**SUBJECT:** Record of Decision Remedial Alternative Selection for the Lower Three Runs Integrator Operable Unit (U) (SRNS-RP-2020-00542, Revision 1 Redline, August 2021) and Savannah River Site's Responses to the Regulatory Comments on the Revision 0 Document, SEMS Number: 35

**SRS Responses to the  
South Carolina Department of Health and Environmental Control  
Comments on the  
Record of Decision Remedial Alternative Selection  
for the Lower Three Runs Integrator Operable Unit (U),  
SEMS Number: 35 (SRNS-RP-2020-00542, Rev.0, March 2021) received April 8, 2021.  
Comments Received June 3, 2012**

**SRS Responses to U.S. Environmental Protection Agency  
Comments on the  
Record of Decision for the Lower Three Runs Integrator Operable Unit (IOU) (U)  
SEMS Number 35, (SRNS-RP-2020-00542, Revision 0, March 2021),  
Savannah River Site, Aiken, South Carolina  
Comments Received: June 21, 2021  
Page 1 of 4**

Figure 8. Sample Locations for EA2 in the Upper Subunit of the LTR IOU

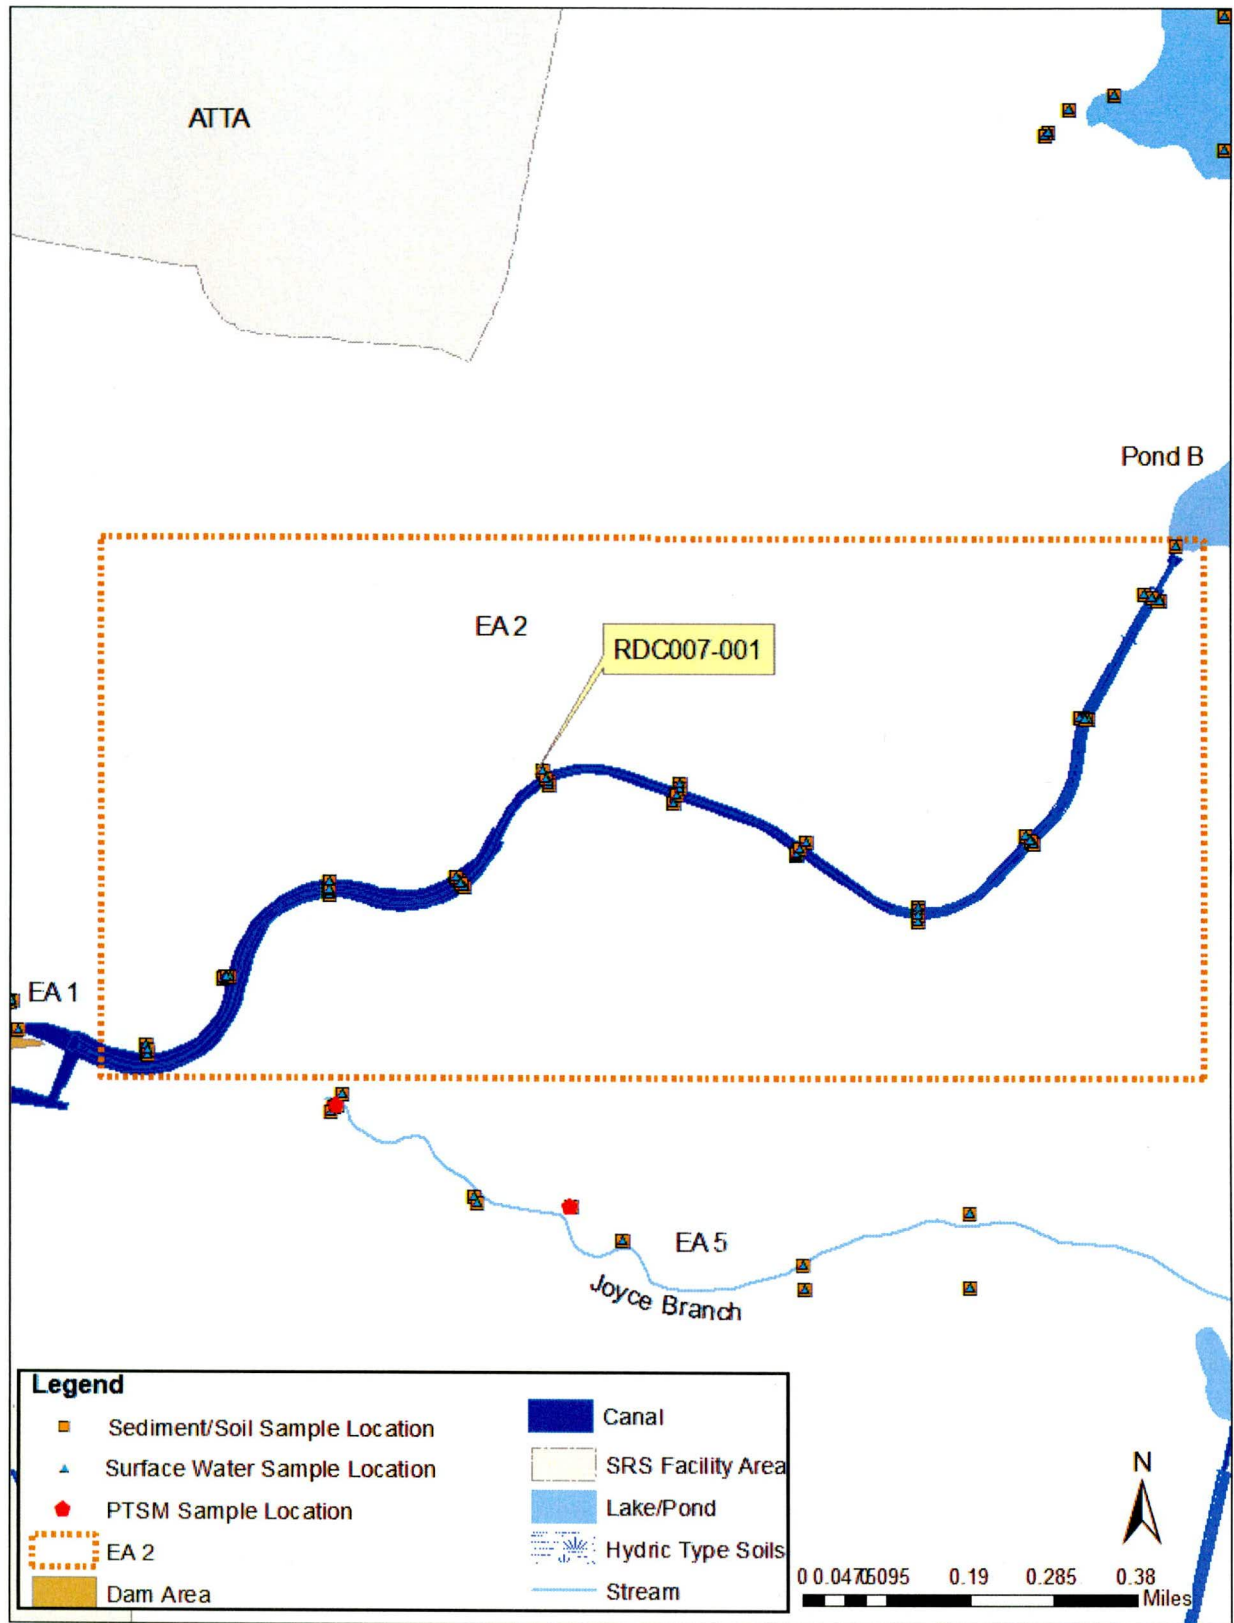
- a. What is the specific purpose of the callouts on these figures with regard to sample locations?

- b. Figure 8 has the PTSM locations for EA 5, but the figure is meant to represent EA 2.

**Response: Agree/clarification. These figures denote the sediment/soil and water sampling locations described in the Baseline Risk Assessment/Remedial Investigation. Some of these locations are identified in this document in Section V, *Media Assessment Results*. For example, the text in Section V, *Media Assessment Results, Exposure Area 2 (Canal From Pond A to Pond B), Cs-137(+D)*, states, “Concentrations ranged from ND to 180 pCi/g with the highest detected concentration at location RDC007-001 collected on 4/14/2010 (Figure 8).” Location RDC007-001 is called out on Figure 8.**

Two of the call-outs, one on Figure 8 for RDC009-002, and one on Figure 14 for LTR-P45, are not needed and will be deleted off the respective figure. The revised Figures 8 and 14 are attached to these comment responses.

**Response: Clarification. The legend indicates PTSM sample locations and although EA2 had no PTSM sample locations, the figure identifies the locations in the adjacent EA5. The legend will remain the same to indicate PTSM sample locations in the adjoining EAs. No change to the document is necessary.**

Figure 9. Sample Locations for EA3 in the Upper Subunit of the LTR IOU

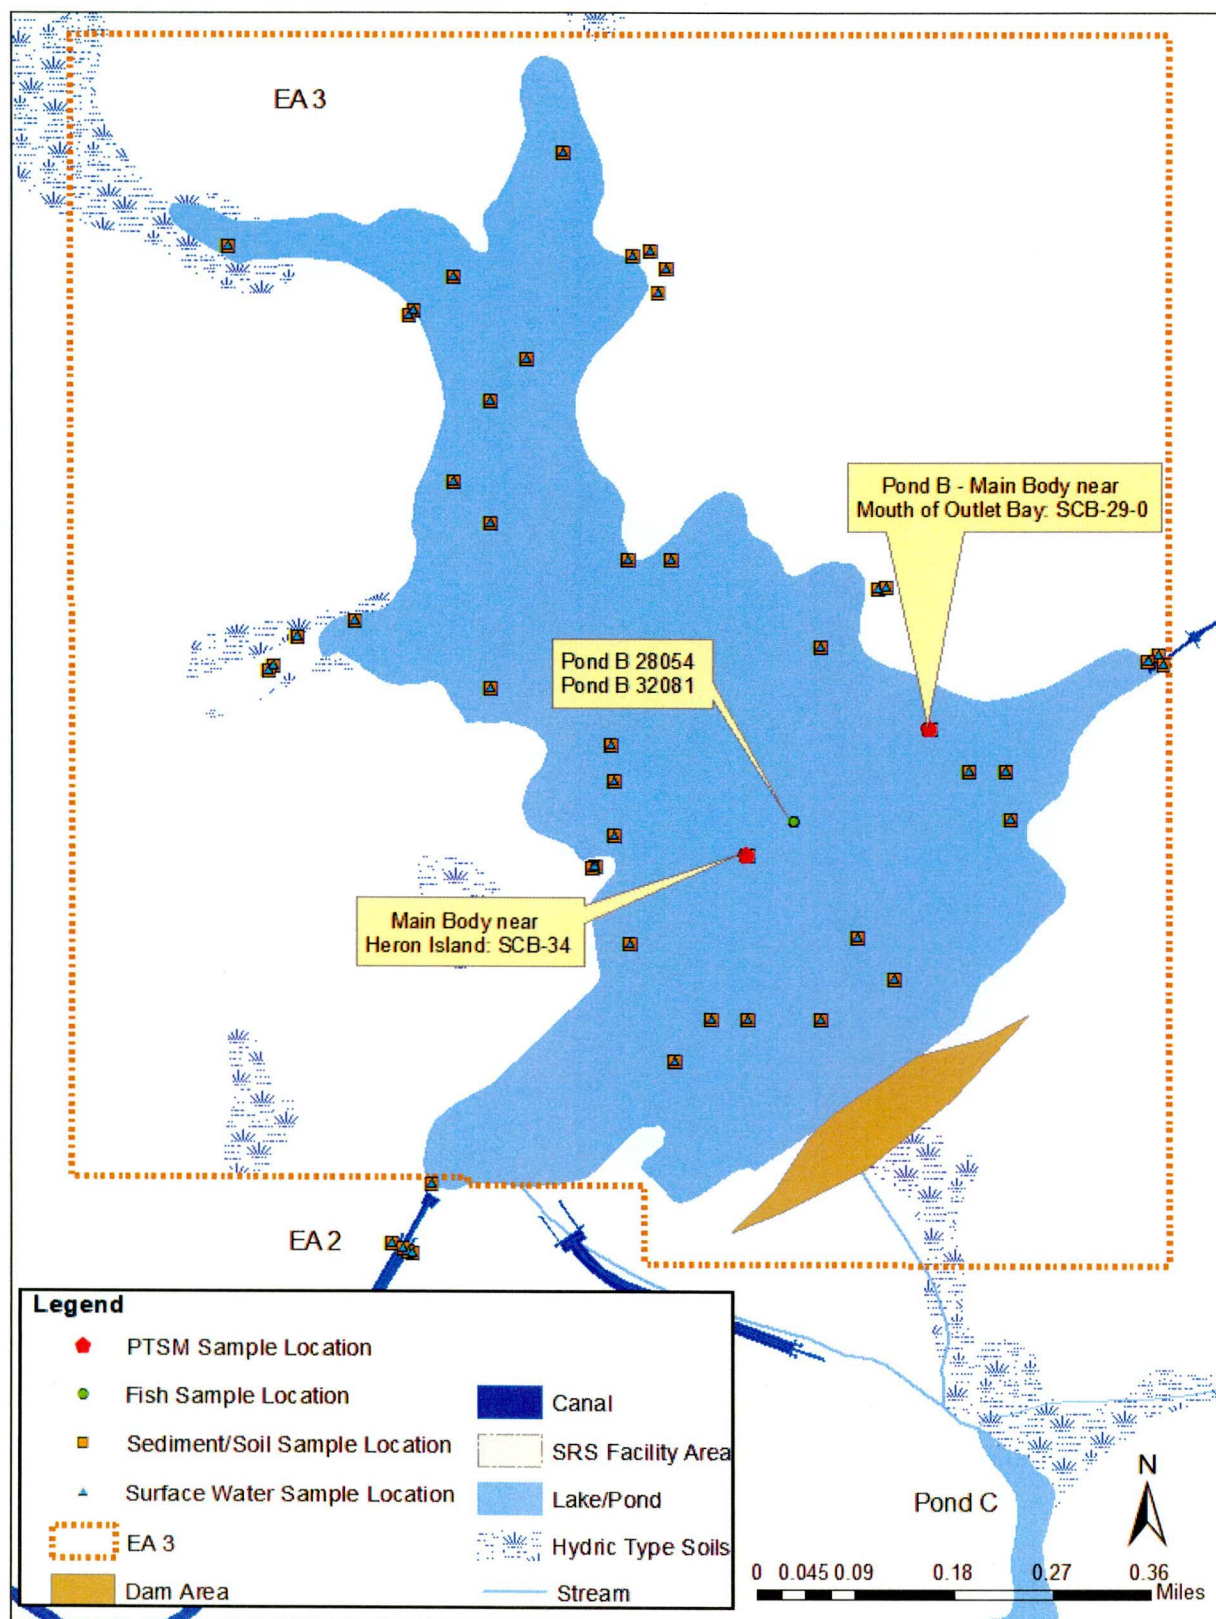
2. Section V, Operable Unit Characteristics, page 10. The third bullet on page 10 describes EA 3 as including Pond B and the overflow canal connecting Pond B to Pond C. Figure 9, which depicts EA 3, shows the overflow canal but does not include it in the boundary designating EA 3. Furthermore, the description for EA 3 on page 10 includes the following language: “The canal flow area (i.e., where contaminants most likely have been deposited)...” This statement would imply the need for previous sampling in this canal overflow area; however, based on review of previous documents and the sampling locations depicted on Figure 9 for EA 3, no sampling at the canal overflow area between Pond B and Pond C was ever conducted. Please clarify the description of EA 3 and whether there could be any potential issues at the canal overflow area between Pond B and Pond C.

c. Figure 9 is missing the PTSM locations for EA3.

**Response: Agree/Clarification. The overflow feature was constructed to allow for emergency discharges that may be required from the reactors. The overflow canal identified at Pond B was evaluated using gamma overflight data as well as visually inspected. From those evaluations and based on the lack of recorded evidence that the feature was ever used, it was not included for additional screening and sampling. To address this comment, the statement, “The canal flow area (i.e., where contaminants most likely have been deposited) is ~3 m (9.8 ft) across the base of the canal.” will be deleted from the third bullet.**

**Response: Agree. The Main Body near Heron Island: SCB-34 and Main Body near Mouth of Outlet Bay: SCB-29-0 locations will be relabeled as PTSM locations on Figure 9. The revised Figure 9 is attached to these comment responses.**

Figure 11. Sample Locations for EA5 in the Upper Subunit of the LTR IOU

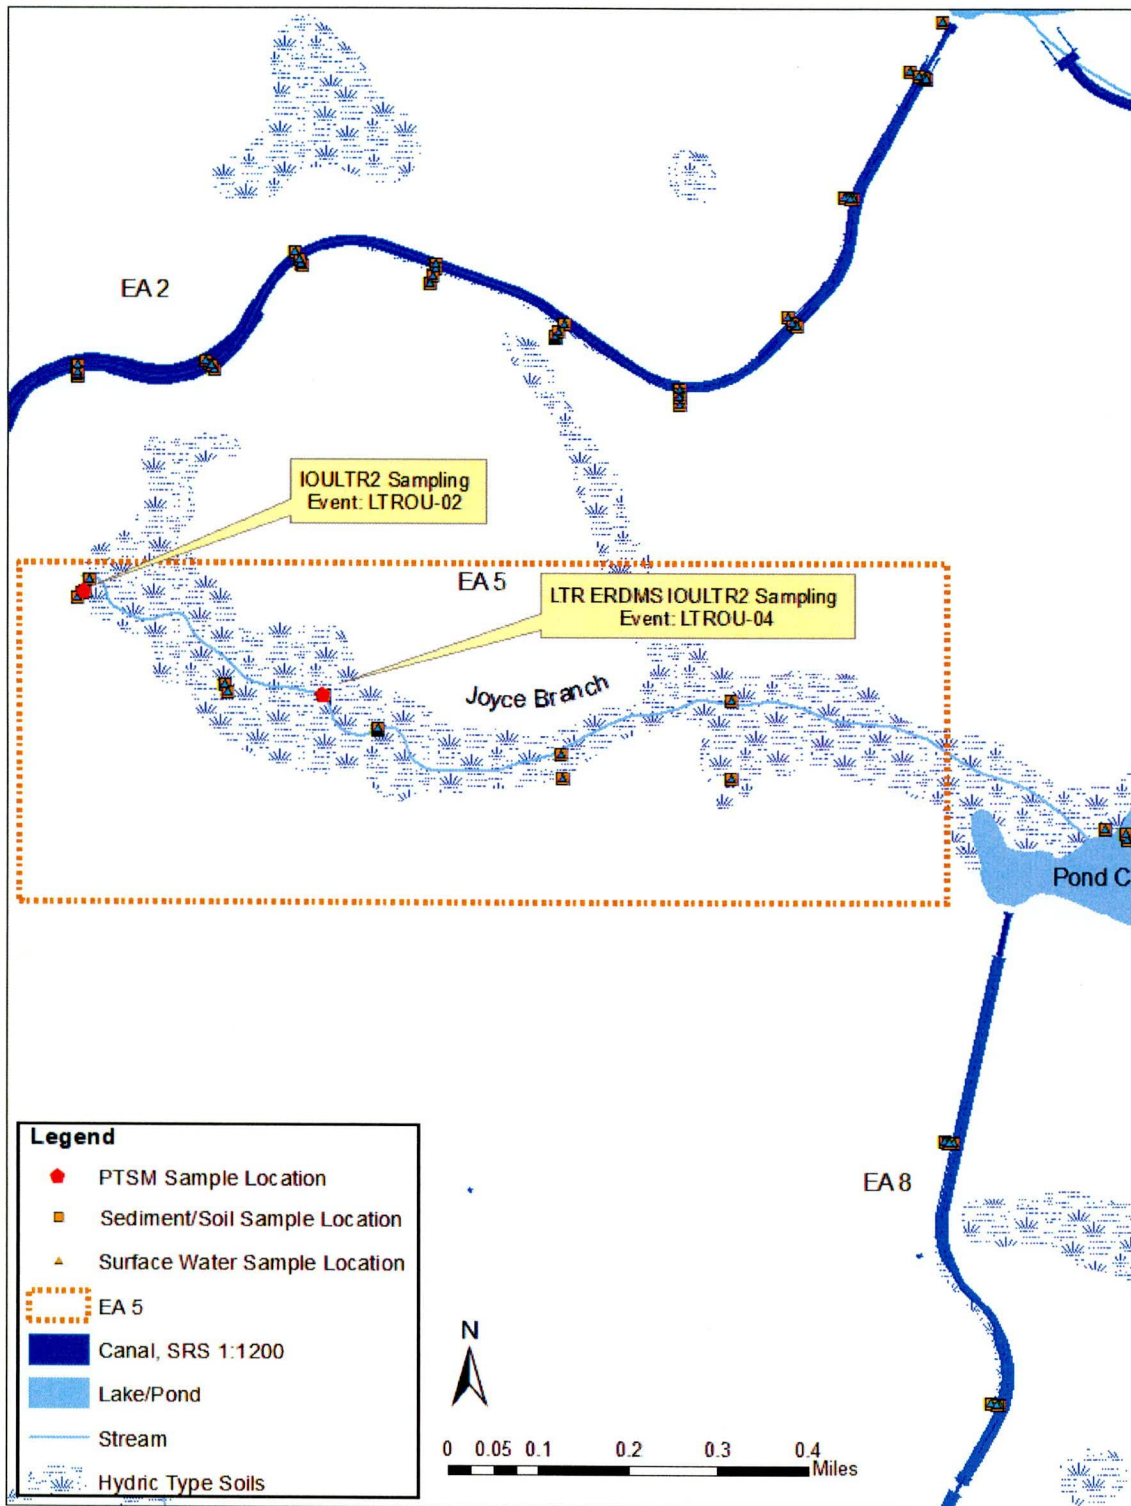
d. Figure 11 is missing the PTSM locations for EA5.

**Response. Agree. The PTSM locations for EA5 will be included in the revised Figure 11 as well as adding PTSM sample locations into the legend. The revised Figure 11 is attached to these comment responses.**
